Re: Florida Power & Light Company
Proposed Turkey Point Units 6 and 7
Docket Nos. 52-040 and 52-041
Supplemental Response to Request for Additional Information Letter No. 004
Standard Review Plan Section 02.04.06 – Probable Maximum
Tsunami Flooding -Question No. 02.04.06-2 (eRAI 4809)

NRC RAI Letter No.: PTN-RAI-LTR-004

SRP Section: FSAR 02.04.06, Probable Maximum Tsunami Hazards

NRC RAI Number: 02.04.06-2 (eRAI 4809)

**Figure 2.4.6-210 Extent of Selected Tsunami Model Domain and Subdomains
SITE, ISLANDS, and DEEP**

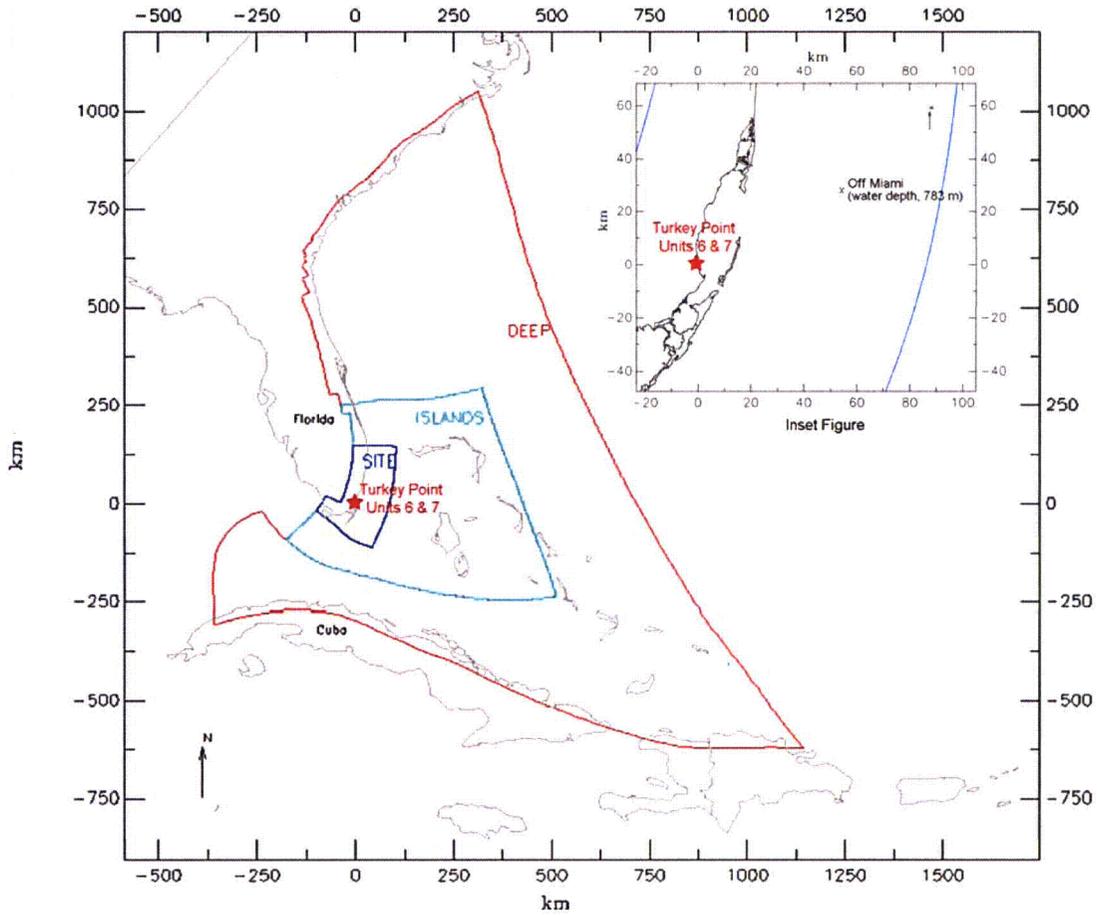
Provide a complete description in the updated FSAR of the numerical modeling methodology used for the revised tsunami analysis and supply water level results specific to the site, taking into account the regional and local (site-specific) bathymetry/topography.

The selected model domain is shown on Figure 2.4.6-210. The east model boundary in deep waters generally follows the simulated propagation of tsunami wave front after 6.5 hours of travel in Mader's analysis (Reference 209). The 6.5 hour wave front is selected to maximize the coverage of the ocean in the model and also allow the model to be defined by one open sea boundary with a uniform boundary condition. This open boundary extends from Havelock, North Carolina to north east of the Dominican Republic. The north and west model boundaries follow mostly the coastlines of the southeastern United States. The south model boundary is set along the northern coastlines of the Dominican Republic, Haiti, and Cuba. The small passage between Haiti and Cuba is conservatively assumed to be blocked. Southwest of the site, the model includes a portion of the Straits of Florida, the area protruding past the Florida Keys, to allow the tsunami wave to travel farther into the Gulf of Mexico so that the effect of this boundary on the site is minimized. Extending the model farther into the Gulf of Mexico is not necessary, as the maximum tsunami water level at the site would occur before the effect of this boundary is reflected back at the site. Consequently, the model boundary in the Gulf of Mexico is simulated as a closed boundary.

A nested grid system with three different grid resolutions is developed using the domain decomposition tool within RGFRID to appropriately resolve tsunami wave modification near the site. The three grid subdomains are shown on Figure 2.4.6-210. The first
